ADDENDUM NO. 01
January 13, 2022

To Drawings and Specifications dated December 17, 2021

CLINE ELEMENTARY SCHOOL CAMPUS REPLACEMENT
FOR FRIENDSWOOD I.S.D.

Prepared by: PBK
11 Greenway Plaza, 22nd Floor
Houston, TX 77046-1104
PBK Project No: 20380

CLINE ELEMENTARY SCHOOL

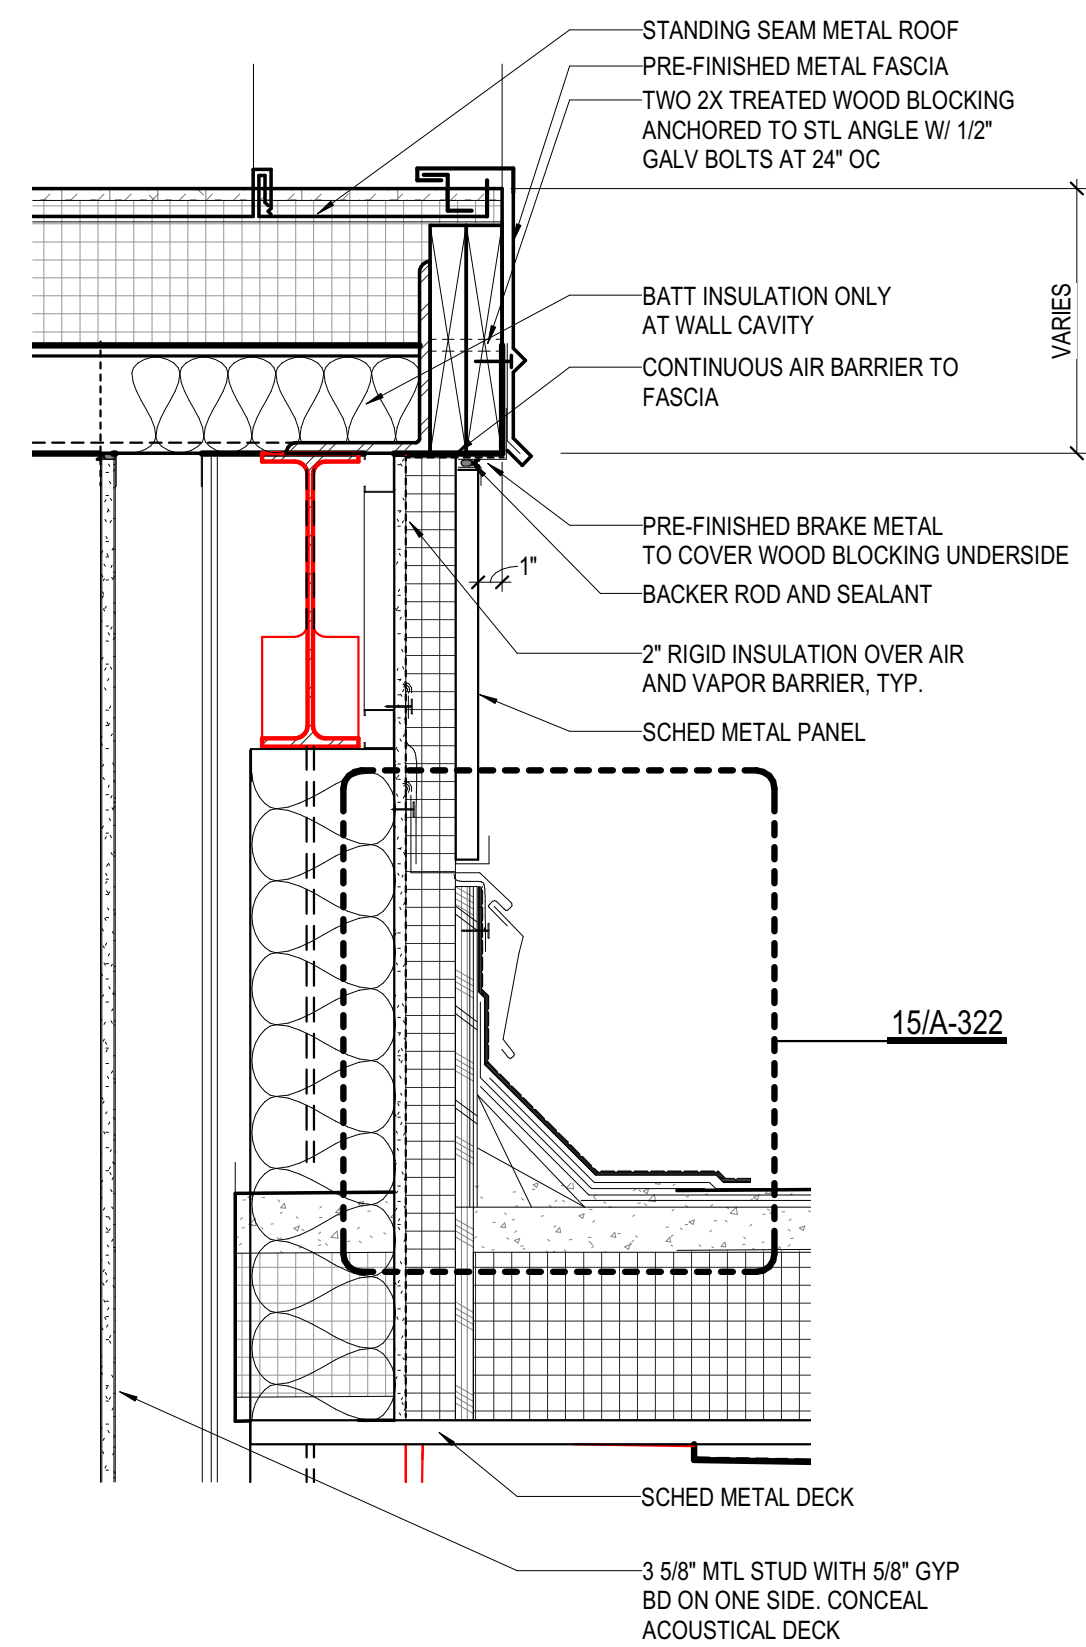
- Item No. 28 **Sheet A-505:** Added mechanical louvers on wall.
- Item No. 29 **Sheet A-722:** Revised wall section details on 02, 08/A-722
- Item No. 30 **Sheet A-731:** Added Door head detail 16/A-731.

ES101

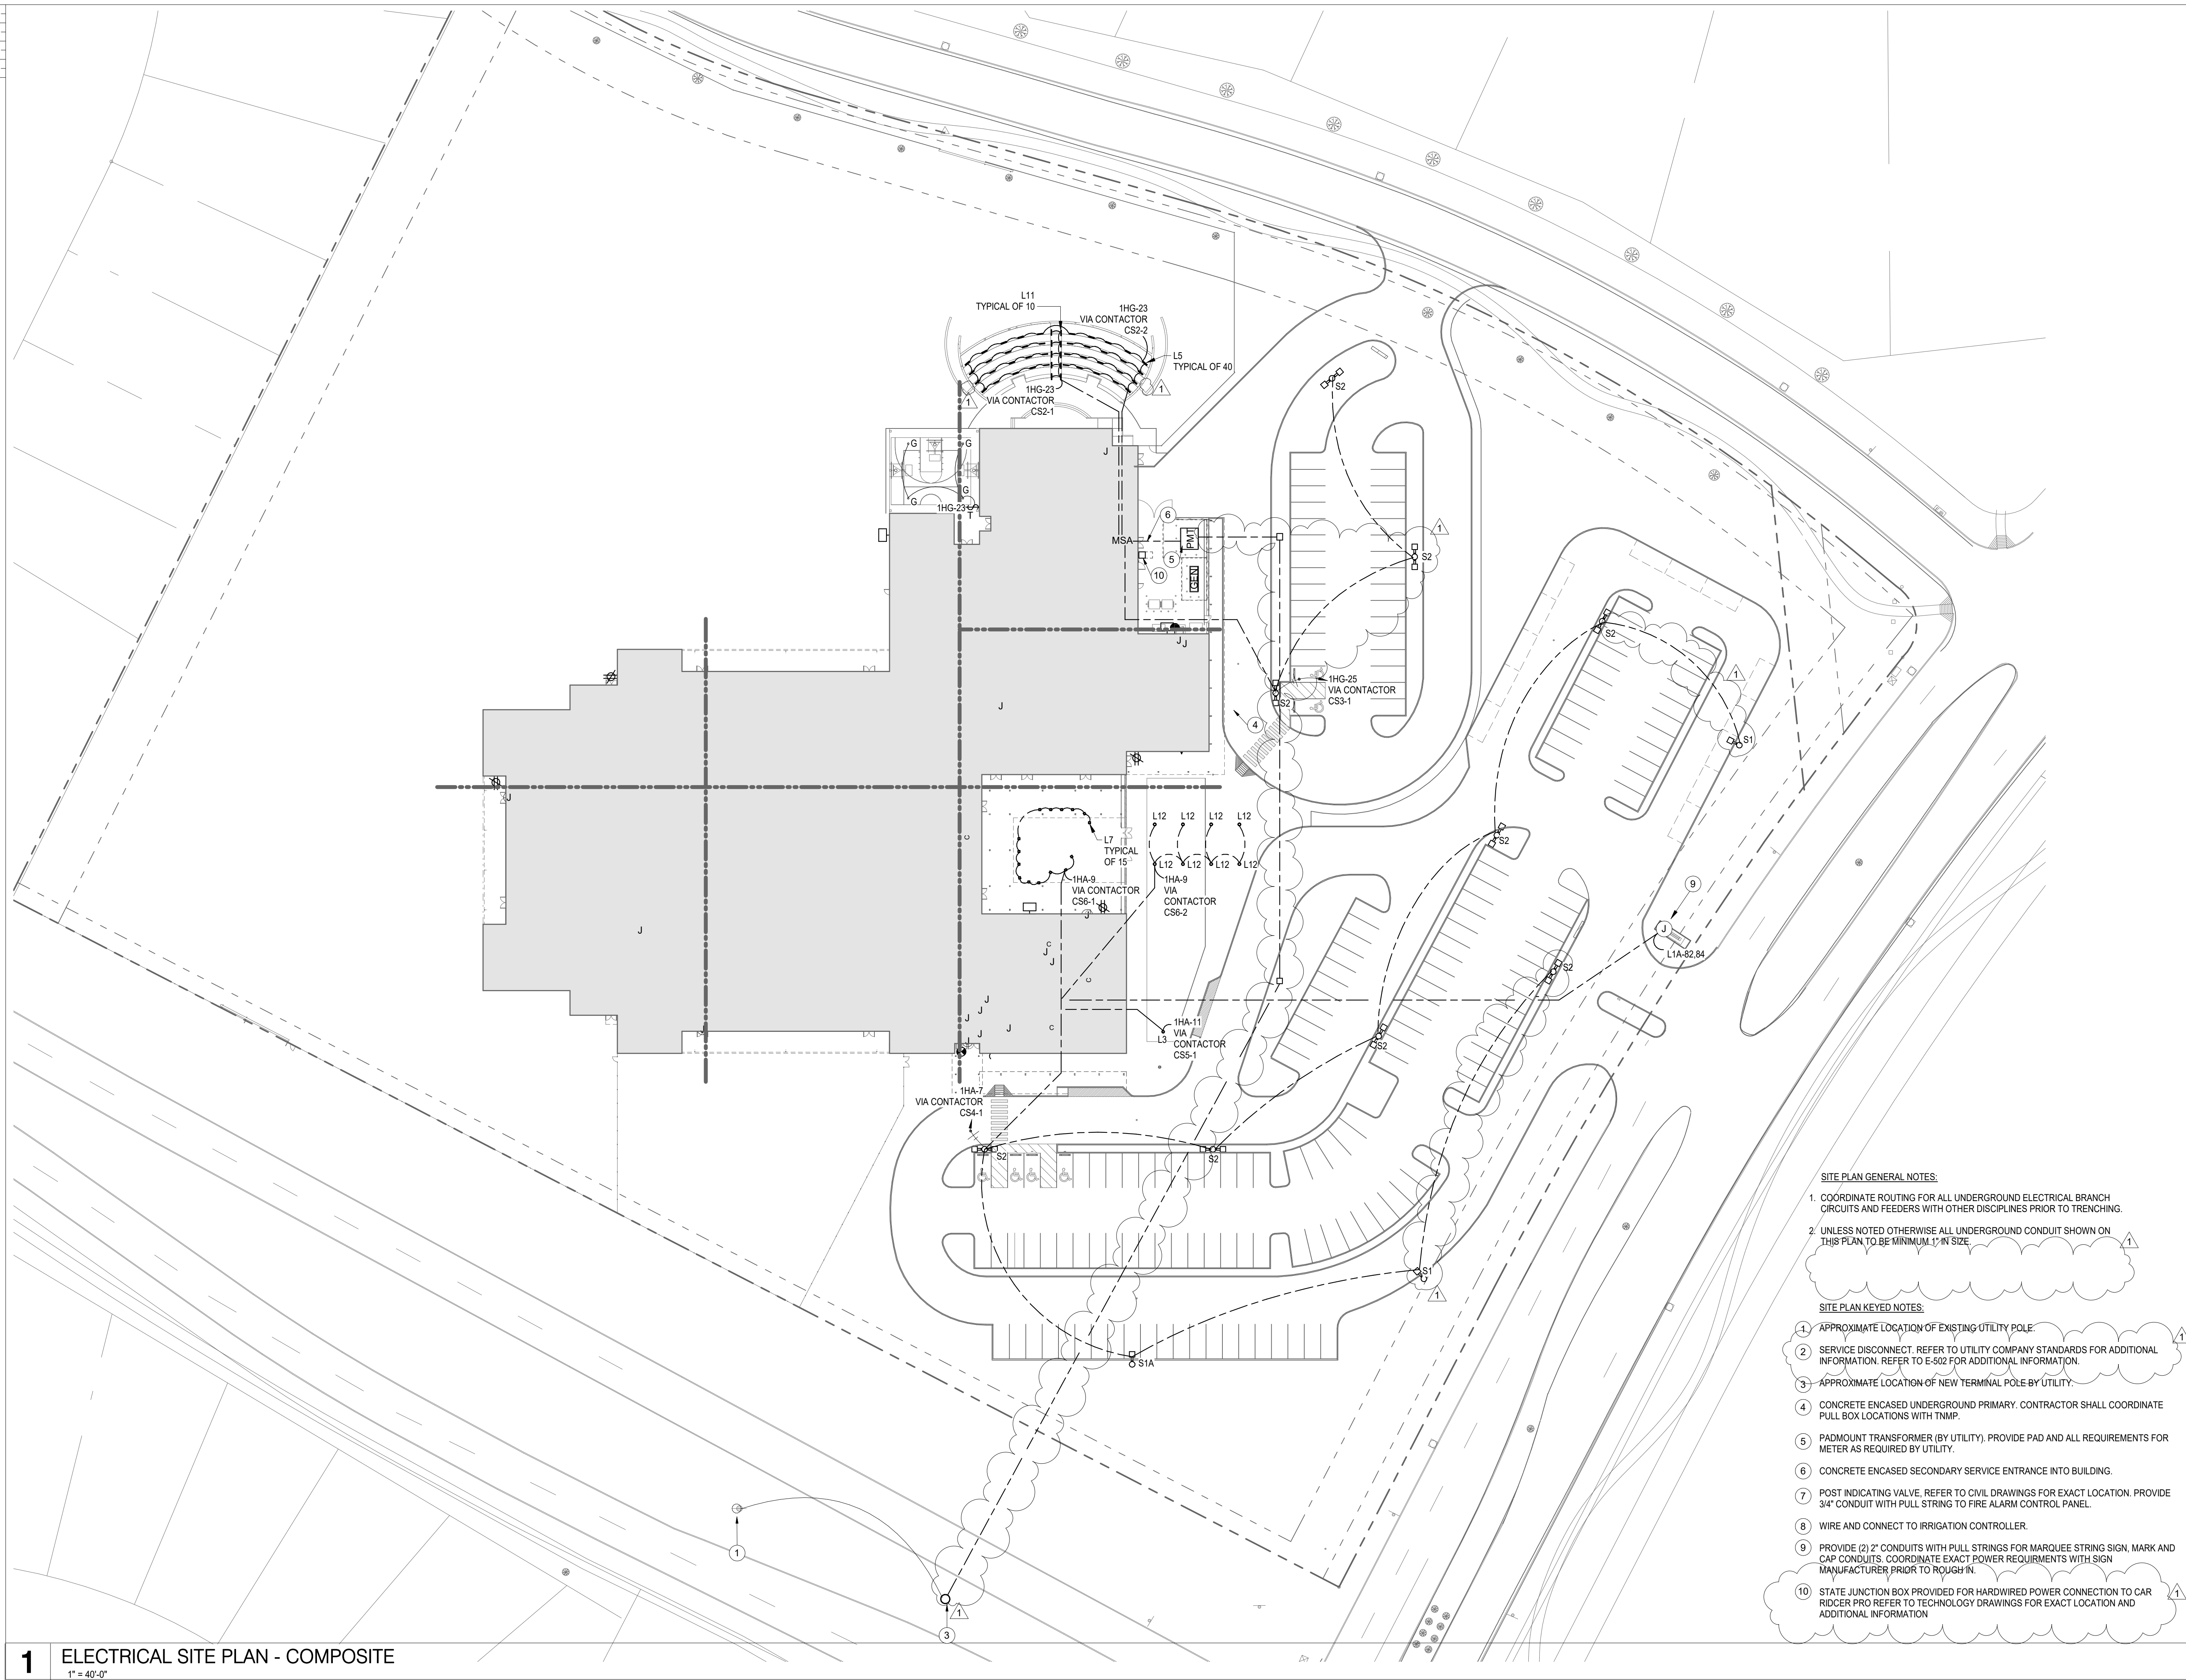
- a. Deleted two L7 fixtures from the outside theater. Refer to revised drawing.
- b. Relocated two S2 parking lot fixtures. Refer to revised drawing.
- c. Added one S1 parking lot fixture. Refer to revised drawing.
- d. Revised utility pole layout and primary utility run to new transformer. Refer to revised drawing.
- e. Added pull boxes to utility service. Refer to revised drawing.
- f. Removed general note number 3 and revised keyed notes to reflect drawing changes. Refer to revised drawing.
